Re: Willbridge Bulk Fuels Area Project  
Consent Order

In the Matter of: )  
 ) DEQ No. WMCSR-NWR-94-06  
CHEVRON U.S.A. PRODUCTS COMPANY, )  
SHELL OIL COMPANY, and UNION OIL ) ORDER ON CONSENT  
COMPANY OF CALIFORNIA, )  
 )  
Respondents. )

Conceptual Site Model - Current Conditions  
Willbridge Facility Risk Assessment  
Willbridge Terminal Group, Portland, Oregon

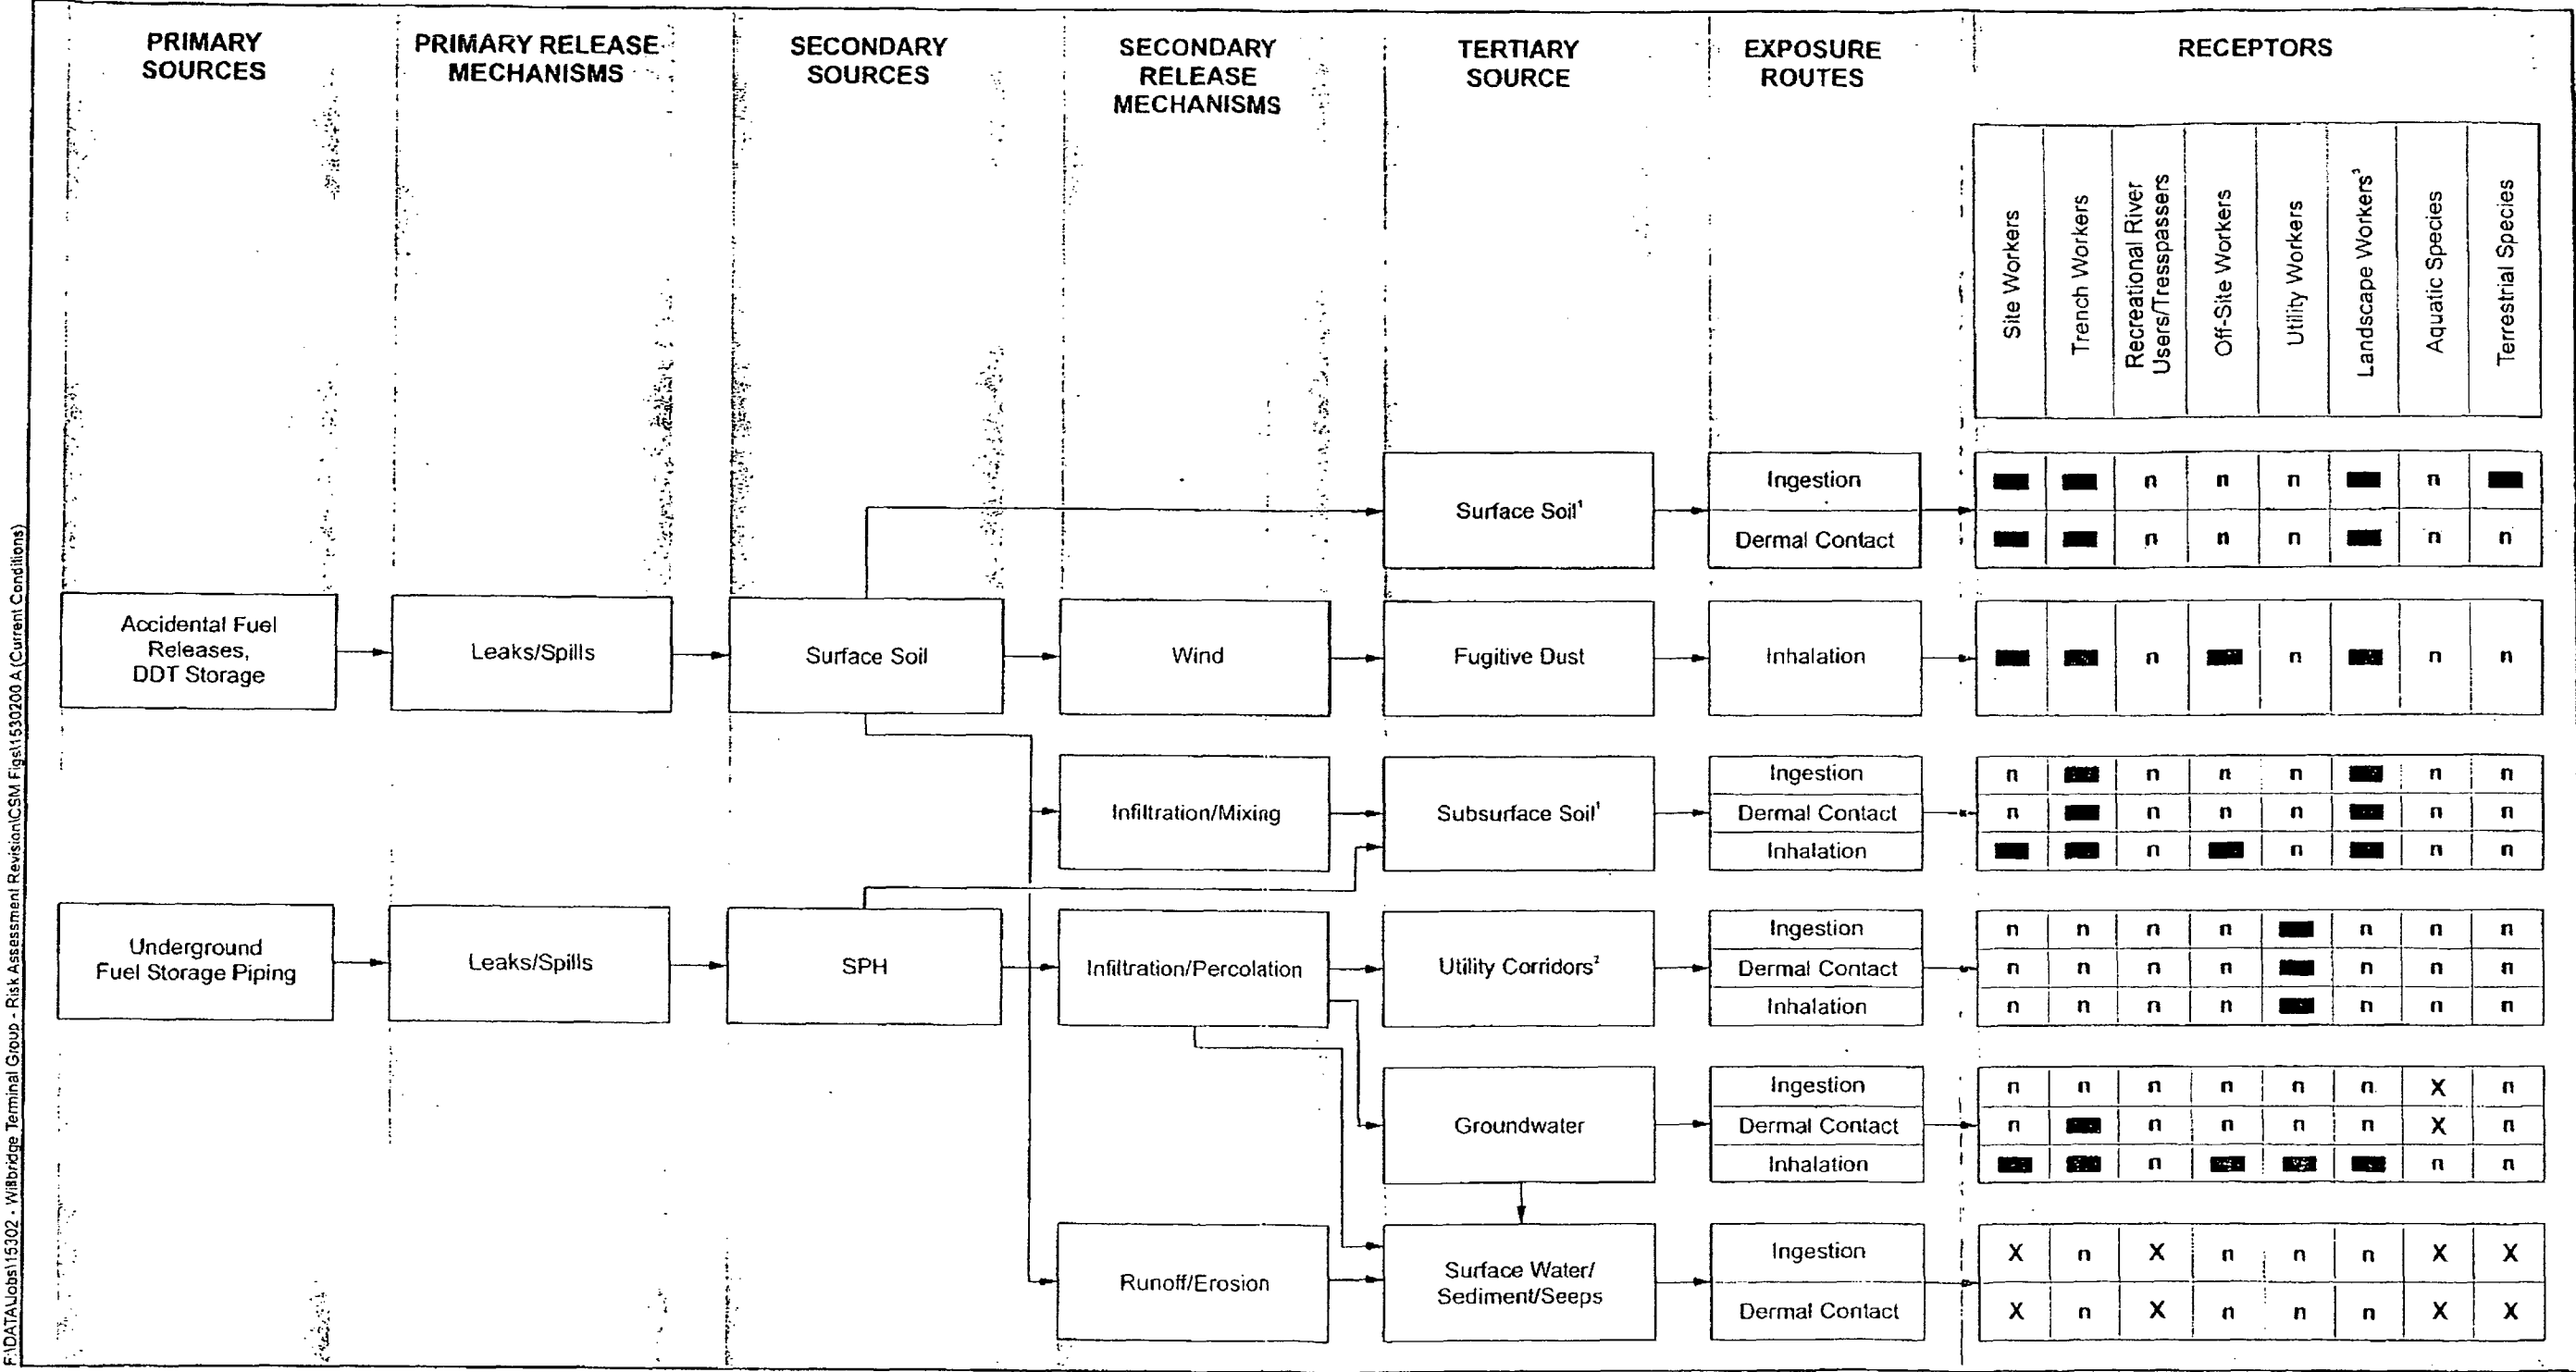
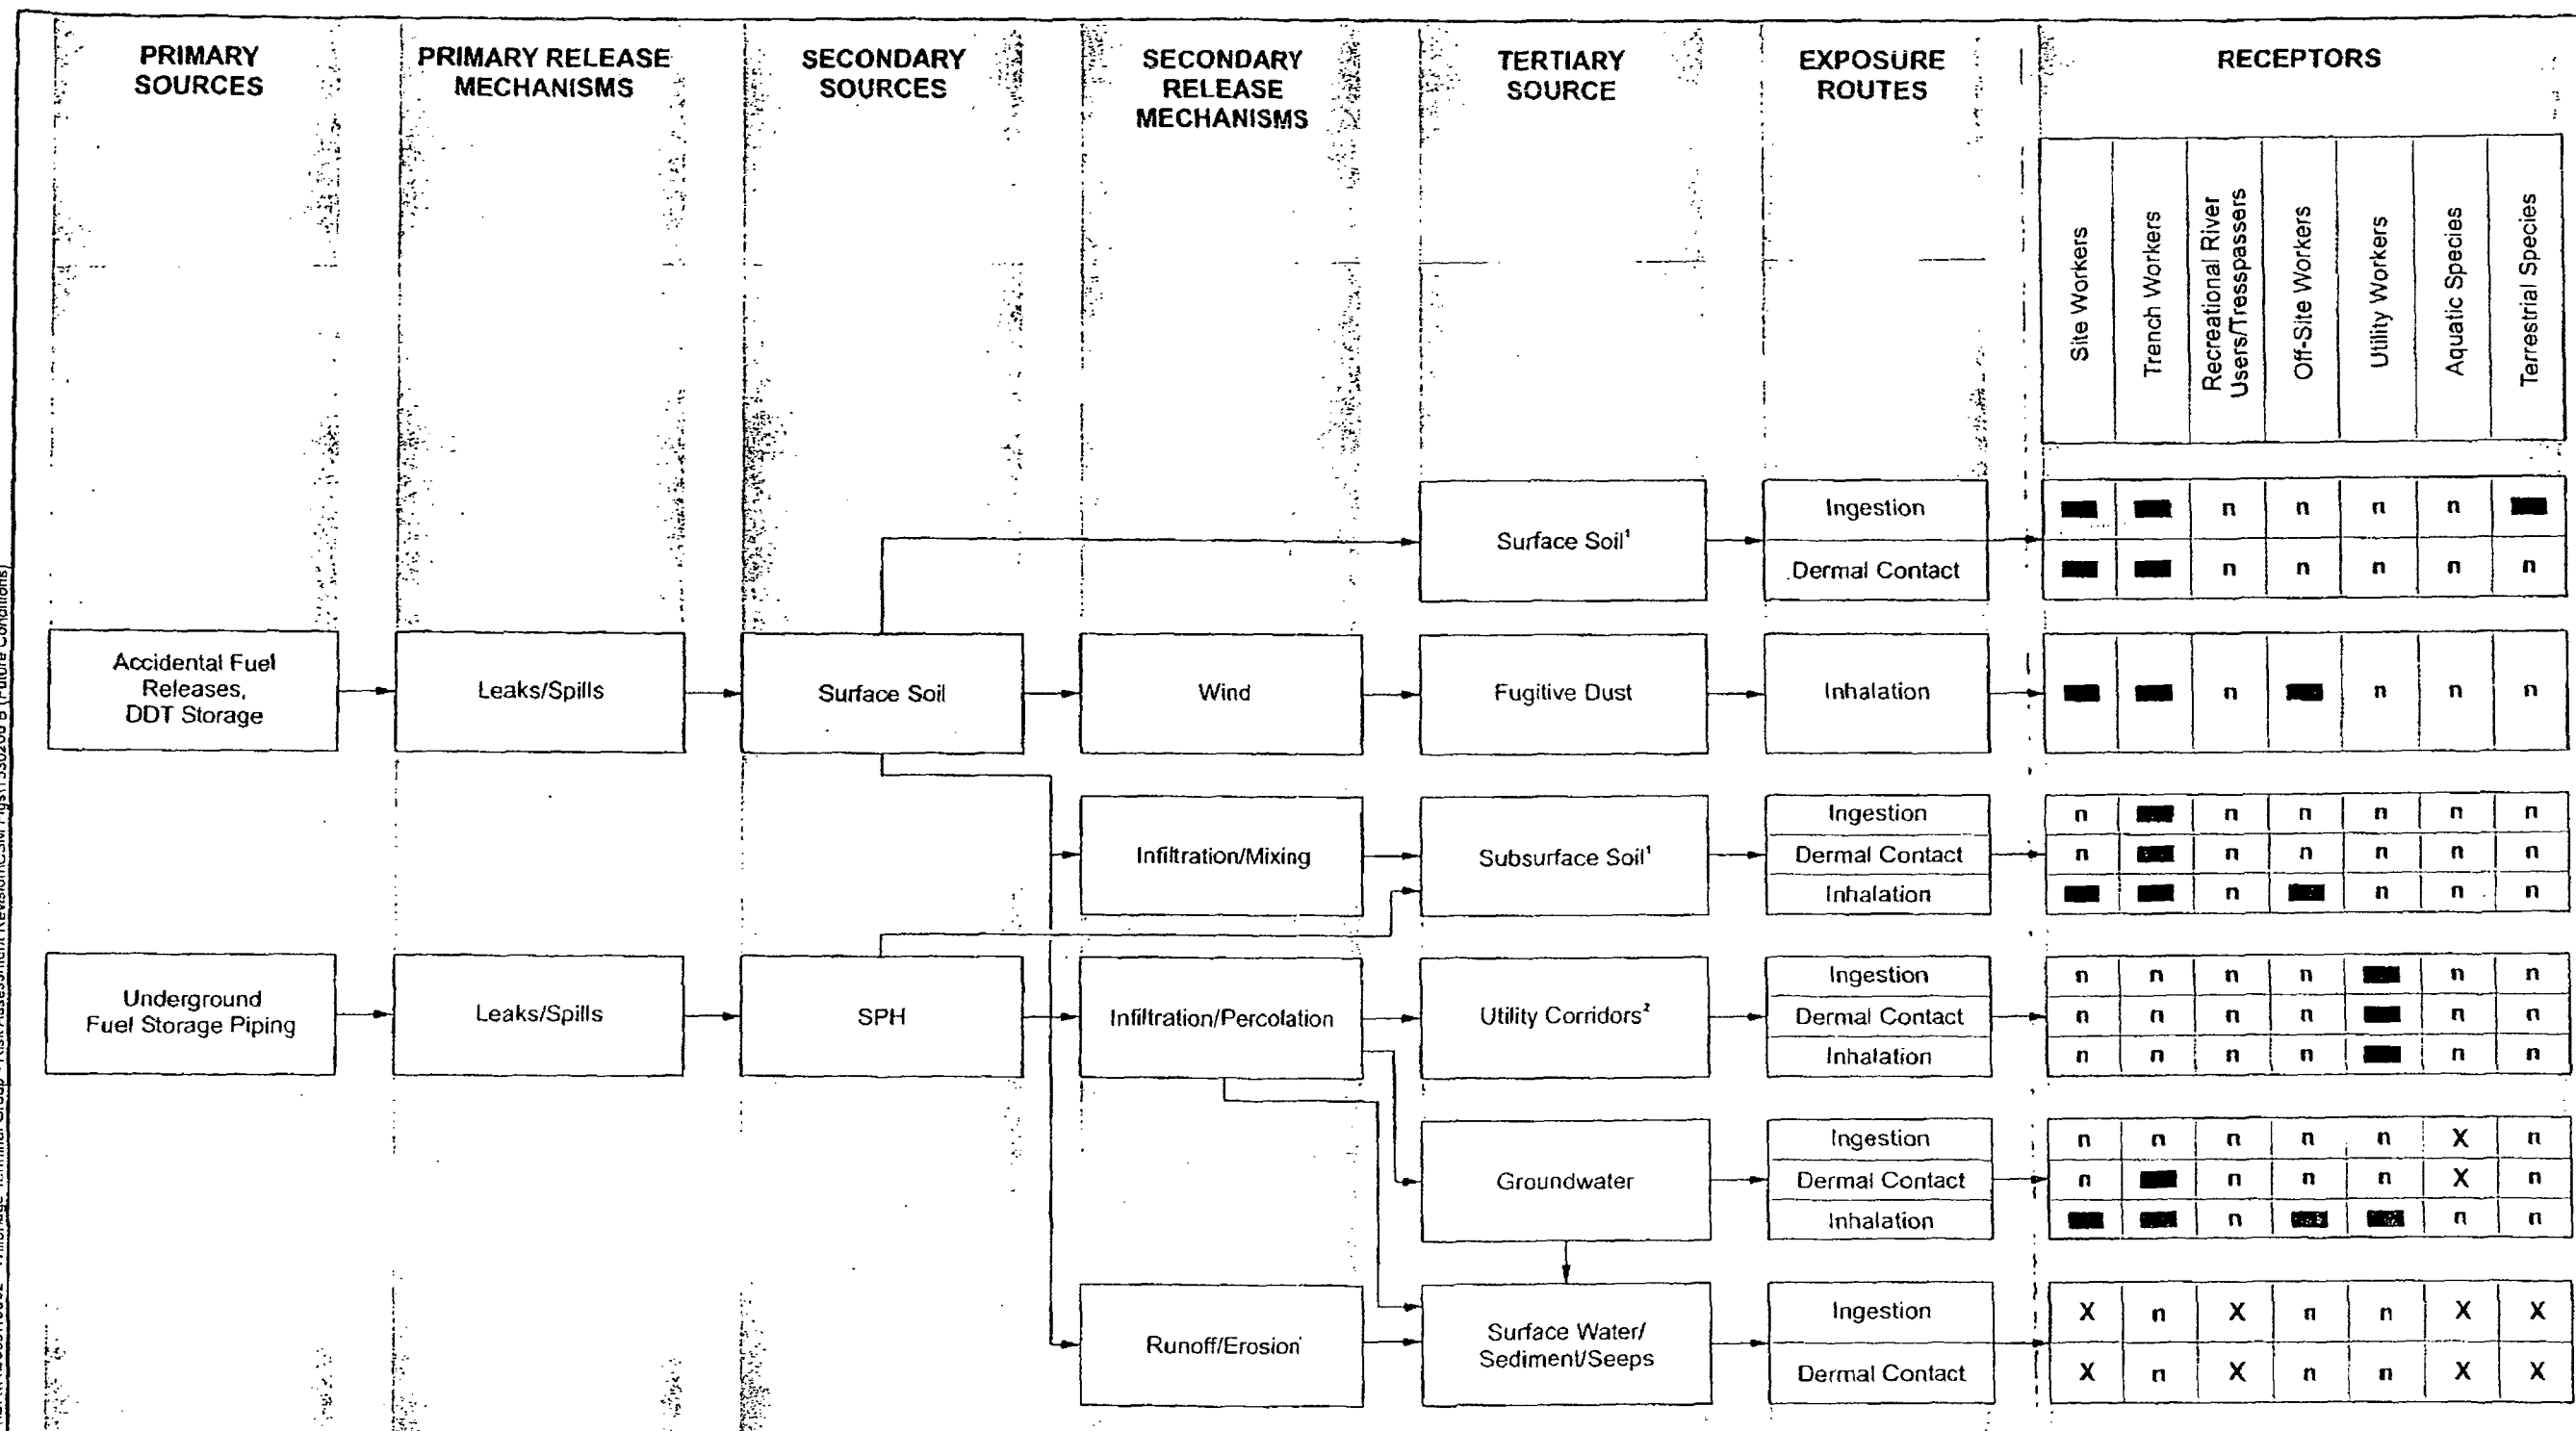
30. Sections 4.0 and 4.4., and Figure 4, Conceptual Site Model. The Conceptual Site Model (CSM) provided in Figure 4 has been modified from the CSM provided in the DEQ-approved RI Work Plan. Sufficient justification should be provided for these modifications.

31. Sections 4.0 and 4.5.1, and Figure 4. DEQ disagrees with the statement that there is no significant terrestrial habitat at the site. During the DEQ site visit on September 5, 2000, DEQ observed noteworthy terrestrial habitat along the lower reach of the Saltzman Creek area and the greenway area to the northwest of the Kinder Morgan dock. This habitat consisted of a combination of sand beach frontage; tangles of blackberry; mixes of a few shrubs, forbs, grasses, and thistle. Kildeer were noted foraging along the beach front and family of nutria were observed occupying the upland

32. Section 4.0 and Figure 4. In the CSM, for those exposure routes identified as undetermined due to insufficient data with which to confirm or eliminate the exposure pathway, the text should identify and discuss how these particular data gaps will be addressed.

Re-evaluate potential exposure of both terrestrial and aquatic receptors from all potential pathways that could adversely impact the Willamette River and the riparian habitats. Revise Figure 4, and the document text as appropriate.

Figure 1  
Groundwater Elevation Hydrograph  
for Wells in Vicinity of Pumping Well RES-New

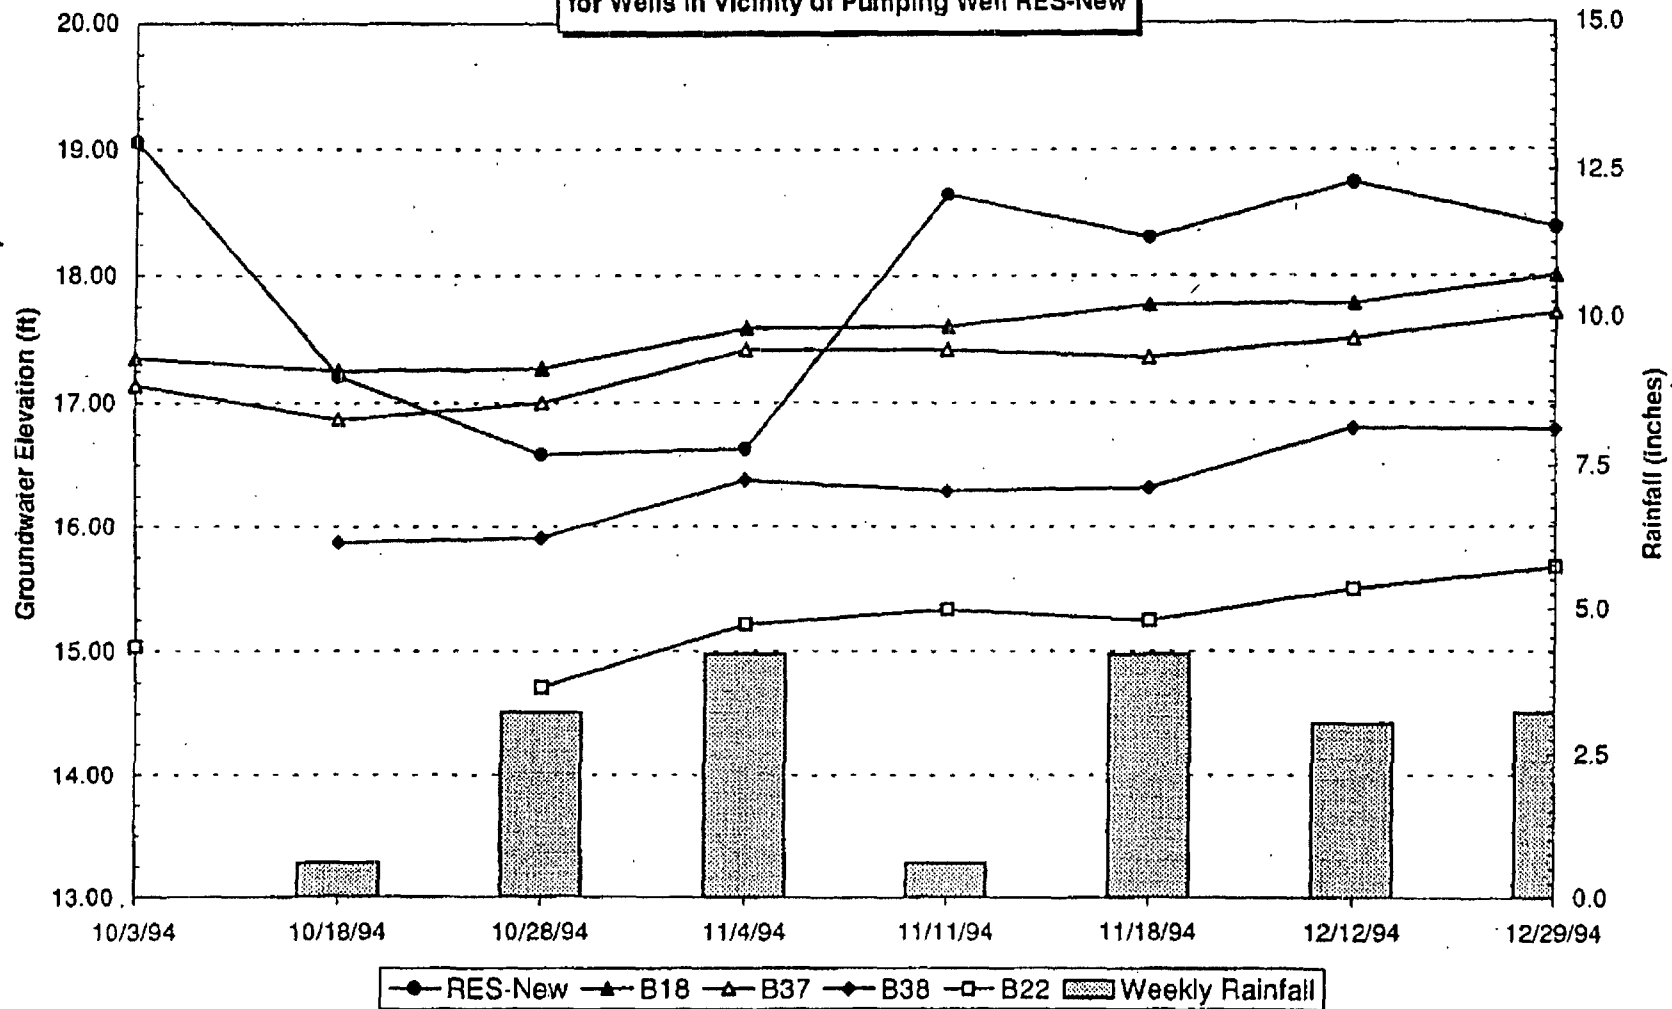
pumping rates between 6 and 13 gpm. While the water level in RES-New dropped after the October 7, 1994 startup (Figure 1), water levels in the other nearby wells have not been affected. Recharge, in the form of heavy rainfall to the shallow aquifer during this period, may prevent pumping induced water level influences from being detected.

**Figure 3**  
**CONCEPTUAL INTERCEPTOR TRENCH DIAGRAM**  
Willbridge Facilities  
Portland, Oregon

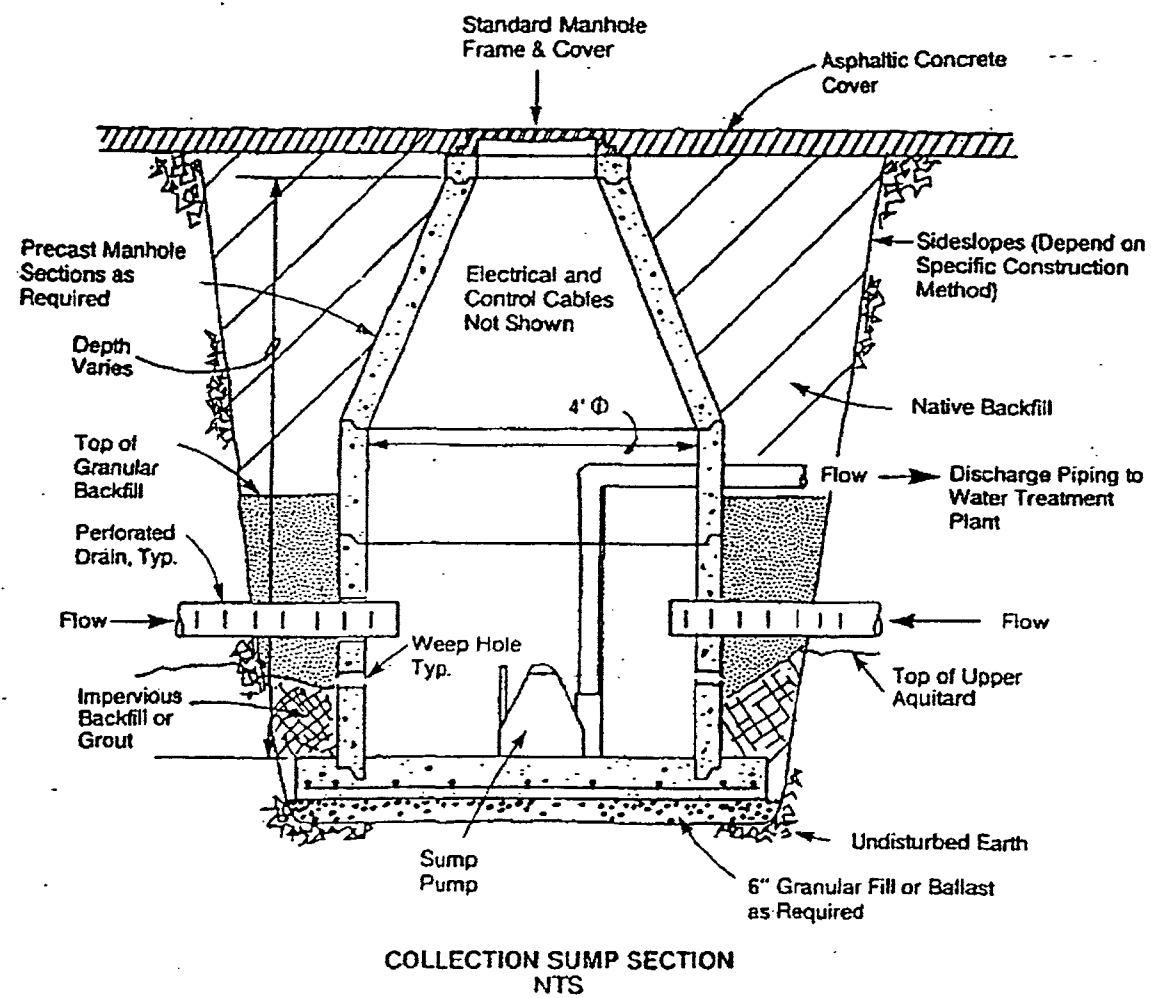
The drain pipe would be constructed of slotted PVC or steel screen (Figure 3) with a high percentage of open area to ensure sufficient hydraulic capacity exists to intercept 100 percent of the flow for the range of conditions present at the site. The screened portions of the trench will be imbedded in a granular fill envelope to trap fine grained material and promote product and groundwater flow through the screen. Fluids will move by gravity flow to
